Title	Motor Controller Board
Designed by	Artem Dementyev
Ver	1.0
Date:	11/5/2015
Time:	6:52:53 PM

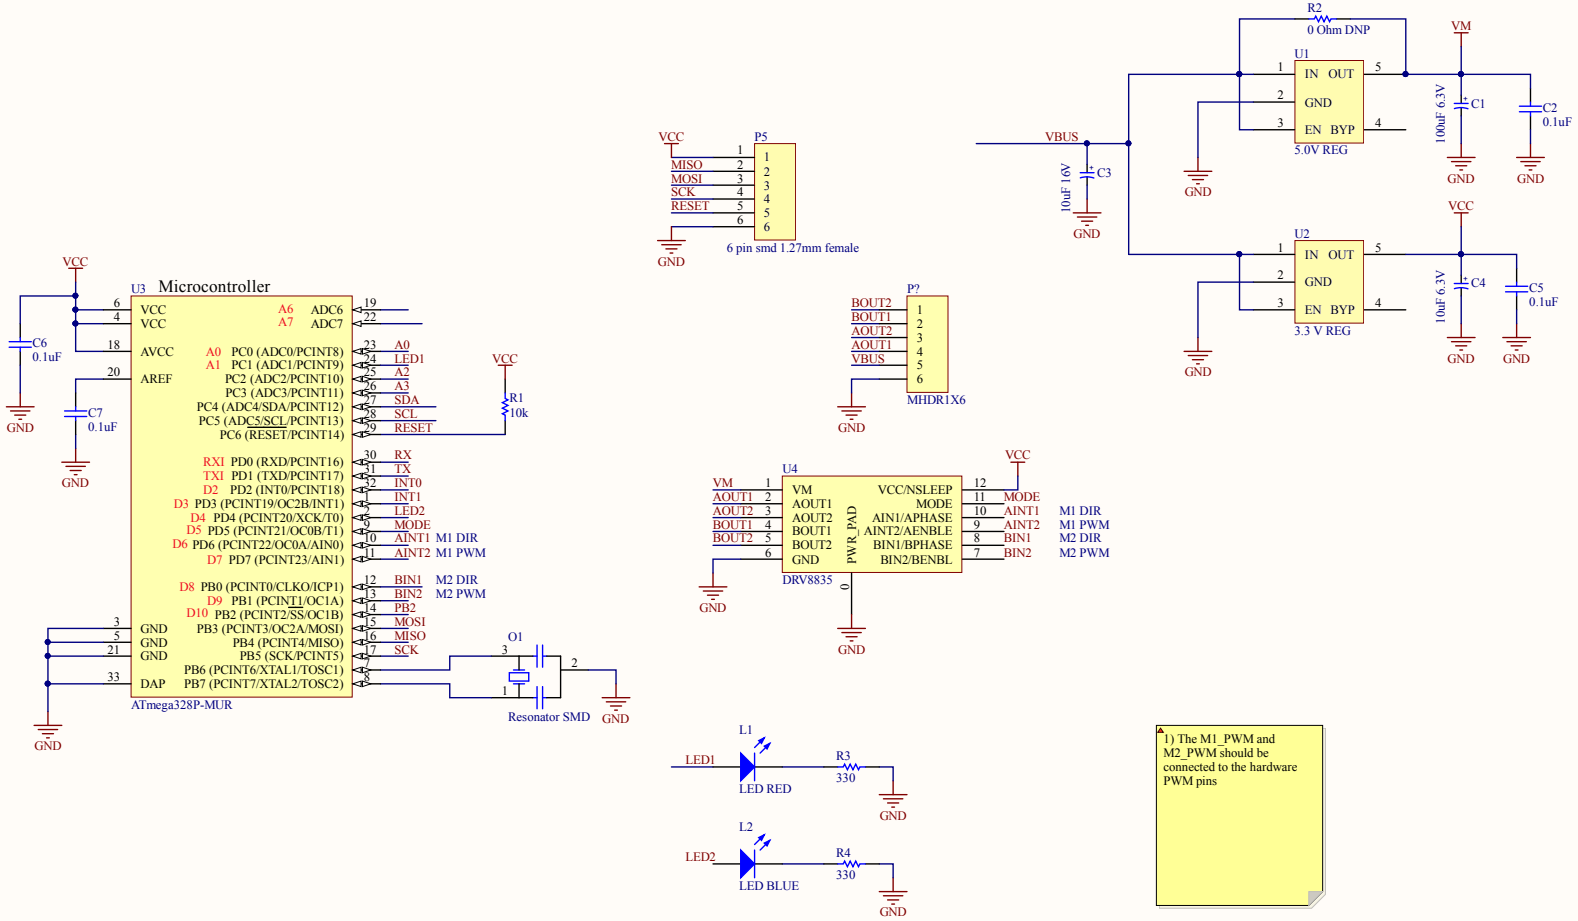
1) The M1_PWM and M2_PWM should be connected to the hardware PWM pins
